April 3, 2003
L-03-058

Subject: Beaver Valley Power Station, Unit No. 1 and No. 2
BV-1 Docket No. 50-334, License No. DPR-66
BV-2 Docket No. 50-412, License No. NPF-73
Reply to Request for Additional Information Regarding Proposed Alternative Repair Methods for Reactor Vessel Head Penetrations (Relief Request No. BV3-RV-04)

Responses to NRC Questions
Beaver Valley Power Station (BVPS) Unit 1 & 2
Additional Information Regarding Proposed Alternative Repair Methods for Reactor Vessel Head Penetrations (Relief Request No. BV3-RV-04)

Figure 1
Beaver Valley Unit 1 Stress Corrosion Crack Prediction for 0.5" Below Weld (Nozzle Uphill)
Longitudinal Inside Surface (Aspect Ratio = 6:1)

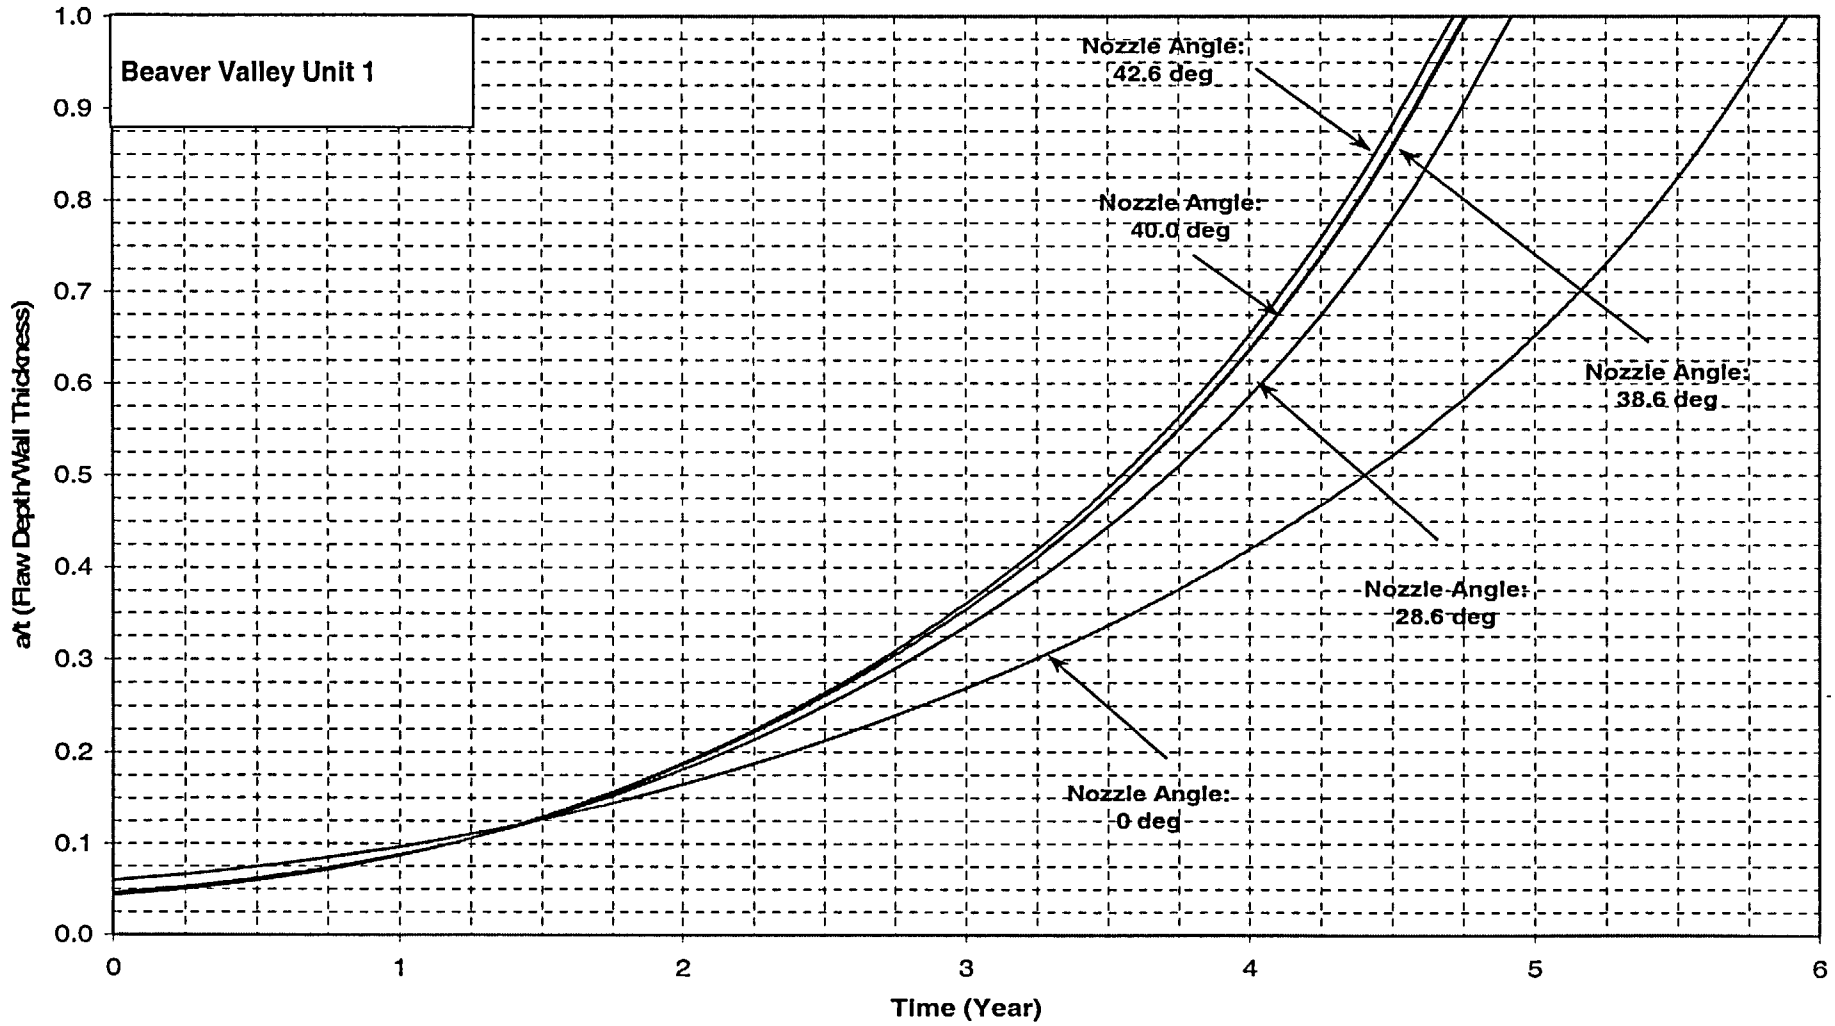
Question 6. Considering residual, thermal and operating stresses, and the largest flaw that may be left on the nozzle inside surface post-repair, an analysis that demonstrates that this assumed flaw will not exceed the ASME Code flaw acceptance criteria of 0.75% through-wall prior to re-inspection should be provided.

As stated above, the tensile stresses on the inside of the tube will be reduced based upon the compressive stresses from the OD imbedded flaw repair. As noted in the response to Question 3, item 2; the small difference in thermal expansion properties between Alloy 52 weld metal and Alloy 600 base metal results in a compressive stress adder on the penetration tube wall. This same conclusion was identified by the staff in the January 2003 letter to North Anna Unit 2 granting relief for application of an embedded flaw repair. Taking a conservative approach to this question, it was assumed that a flaw existed on the inside of the tube in the presence of the operational and residual stresses which exist before the repair occurs, and the analytical results are provided in Figures 1 and 2 (attached).

To further support the conservatism of this assessment, flaws were postulated at a location 0.5 inch below the attachment weld, and at either the uphill or downhill location on the tube. The results are shown in the attached Figures 1 and 2, which were prepared from an existing analysis of a Westinghouse 3-loop plant of similar design and construction to BVPS Unit 1. The specific results that apply to the BVPS Unit 1 penetrations being repaired (numbers 50, 51, 52, and 53) are for angles of 38.6 degrees. The angle mentioned is the angle of intersection between the tube and the head.

The crack growth calculations shown here used a methodology consistent with the recently approved Section XI flaw evaluation approach, with a PWSCC crack growth law that is consistent with the MRP-55 report. Figure 1 shows the results for an axial flaw on the uphill side of the nozzle. Curves were developed for a range of nozzle angles, but the governing case for Unit 1 is for an angle of 38.6 degrees, which corresponds to the angle of the tubes in which indications were found. It can be seen that at least 4.25 years are required to grow a flaw from the threshold for initiation at 9MPA sq-rt-m to a depth of 75 percent of the wall thickness. This is a very conservative calculation because the inspection has shown that there are no flaws of any depth on the inside surface of the penetration, and because no benefit was taken for the compressive residual stresses induced by the weld repair.

Another measure of the conservatism is to look at the size flaw that would grow to the ASME limit of 75% of the wall thickness in one fuel cycle. From Figure 1, it can be seen that a flaw depth of over 30% of the wall would be required to have such growth.

A more general approach would be to consider all the tubes, regardless of where indications might be found. The most limiting penetration in Figure 1 is the 42.6 degree penetration, and for this case at least 4.2 years would be required to grow a flaw to the allowable depth of 75 percent of the wall thickness.
